# ALERT SERVICE BULLETIN

RESTRAINT SYSTEMS - OPERATORS OF AIRCRAFT WITH PACIFIC  
SCIENTIFIC COMPANY, HTL/KIN-TECH DIVISION  
RESTRAINTS INSTALLED

**A25-1124A**

Figure 1. Location of Manufacturer's Date and Marking of Refurbished Parts

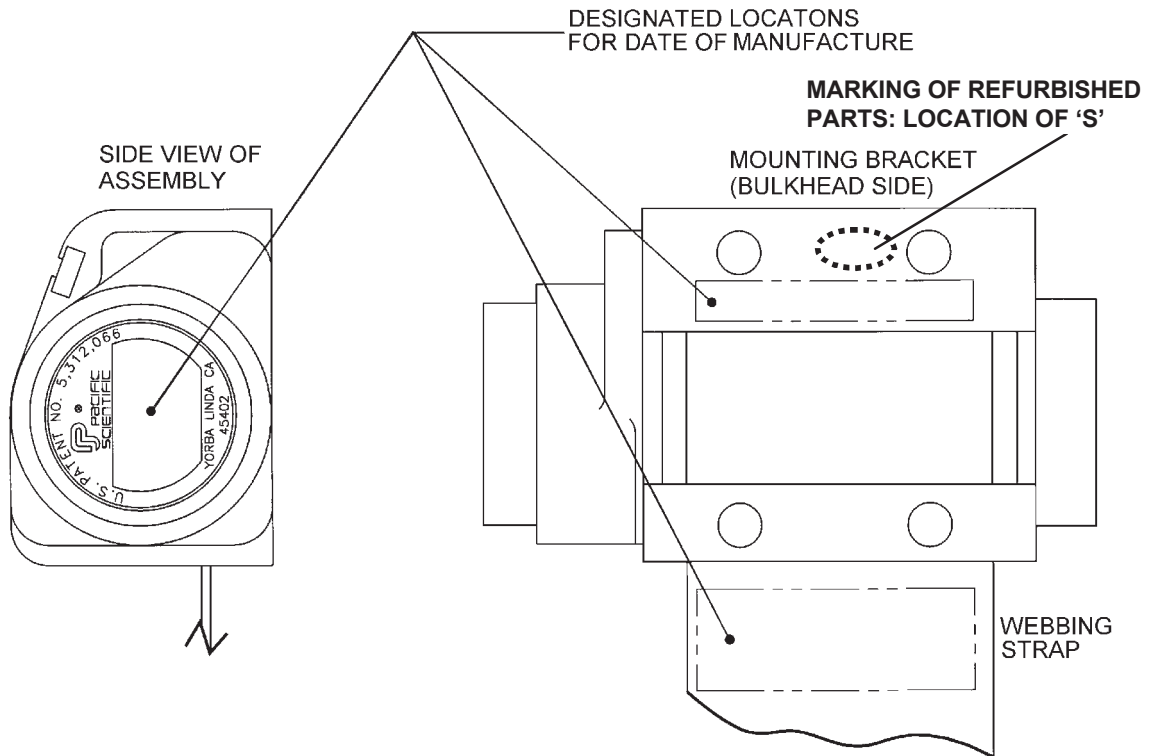
Parts serviced or refurbished will be ink stamped with the date and an “S” on the back of the frame. This stamp will indicate the Aluminum shaft has been replaced with the Steel shaft. (See Figure 1.)
